Access Compliance Report Public Rights-of-Way (Curb Ramps)

Main Street: WICKSHIRE_LN Cross Street: BELLEFORD_RD Location: W

ADA ID: RPRK220103134930 Ramp Type: Type 1 - Perpendicular Diagonal Initial Pass/Fail: Pass Overall Compliance: No Severity Score: 10

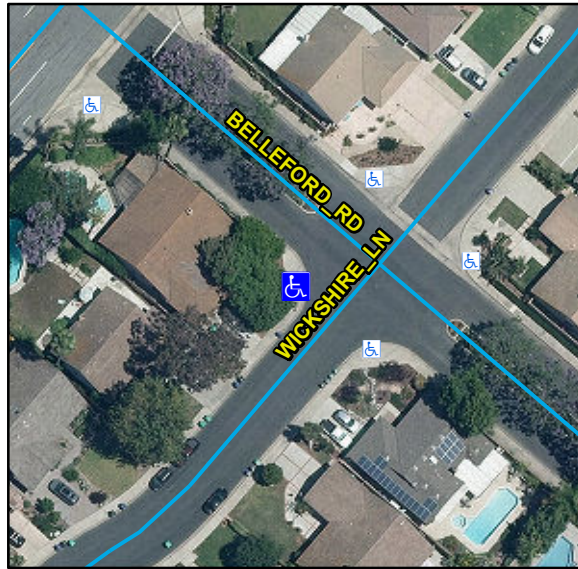
Remove & Replace Curb Ramp With Two New Directional Ramps or Equivalent.

R304.2.1, R305, STD 1115
